# UNITED STATES PATENT AND TRADEMARK OFFICE

# Office Action Summary

10/801,750

YURKOVICH, RUDOLPH N.

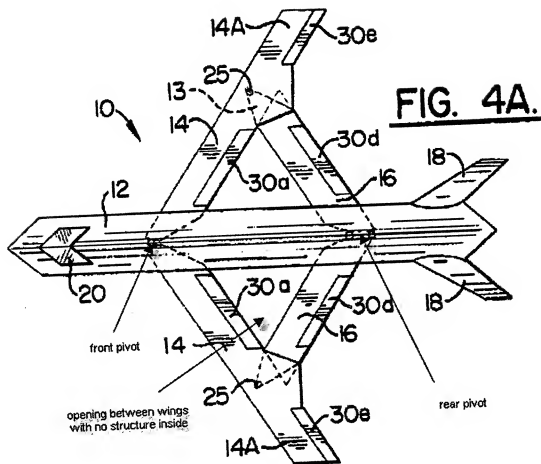
a. With respect to the limitation "no other portion of the aerodynamic body being positioned in the opening" the examiner maintains that there is a section approximately near the intersections of the forward and rearward wings on both sides that is free of any "portion" positioned in the opening, this seen near the A

in figure 3 at least. As seen in the figures the opening which is needed according to the claims which is stated as being "between the left side and right side forward sections and the left side and right side rearward sections", therefore the examiner has chosen to choose between sections of the left forward and left rearward, on one side which opening is seen on the left side and also there is an opening symmetrically seen on the right side of the craft. Also note that because of the breadth of the claims this can also be seen as claiming only one opening and not any corresponding opening because the opening for example on the left is between the front and rear and left and right wing sections, it is just not symmetrically located or located in the middle of the left and right and front and rear wings.

opening is seen in the figure 4a at least, in that between the left forward and rearward wings the opening is also between the right forward and rearward wings, the opening on the left side of the craft is the one referenced. The opening can be seen to be between all the wings, however it is closer to the ones on the left side in the given case. Also note that because of the breadth of the claims this can also be seen as claiming only one opening and not any corresponding opening because the opening for example on the left is between the front and rear and left and right wing sections, it is just not symmetrically located or located in the middle of the left and right and front and rear wings. See below modified figure.
